PAVED
SIDEWALK/ DRIVEWAY

Application No. 11753

Driveway Review Form

30 Moynan Street

Driveway Review

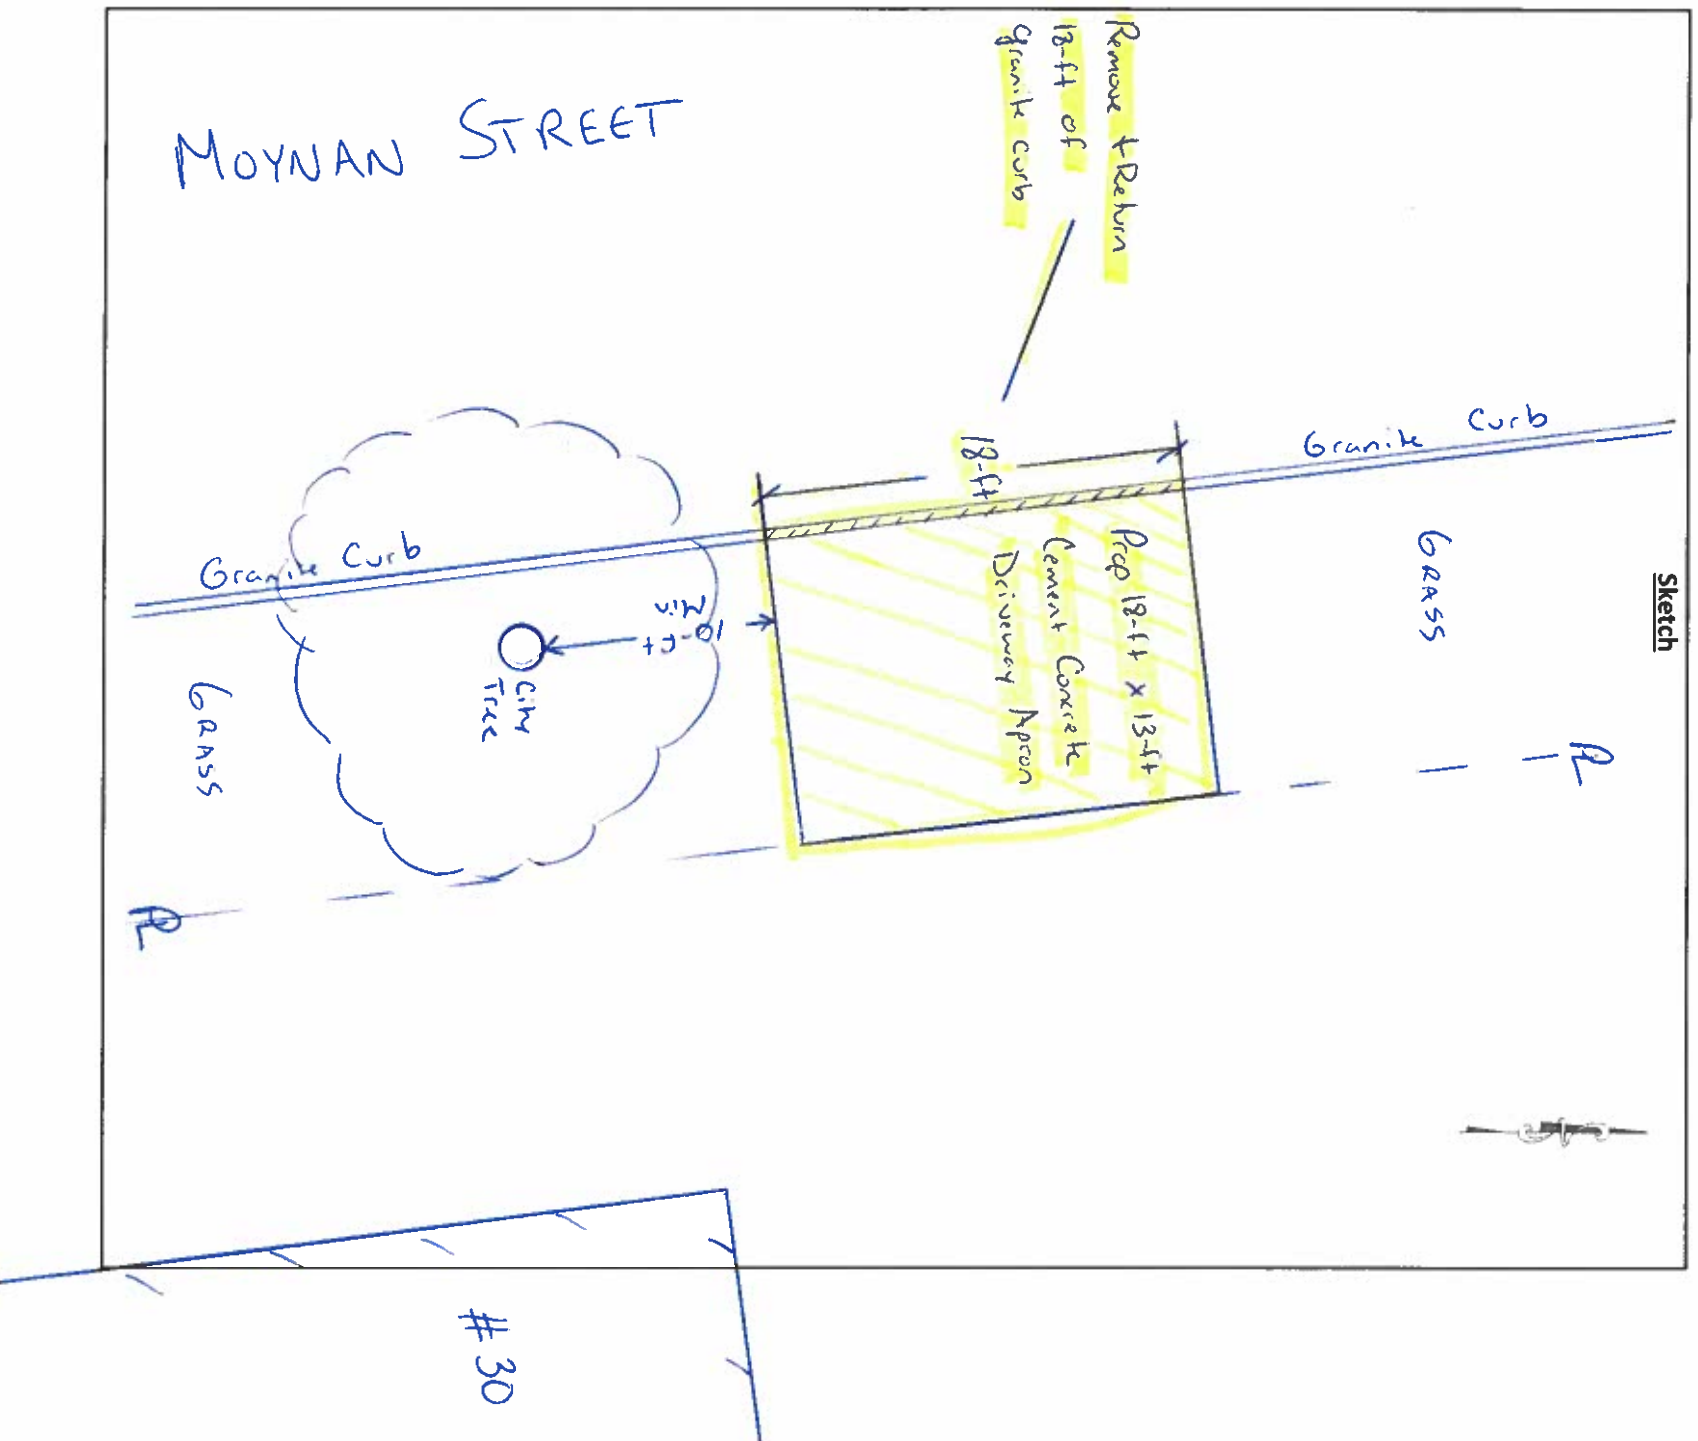
Granite Curb: Remove and return 18-ft granite curb.

Additional Inspection Notes: 1. Curb return above. 2. Install new 18-ft x 13-ft CEMENT CONCRETE driveway apron in accordance with the most current DPI Specs. *Must be pre-inspected by DPI. **Must maintain 10-ft buffer from City tree.
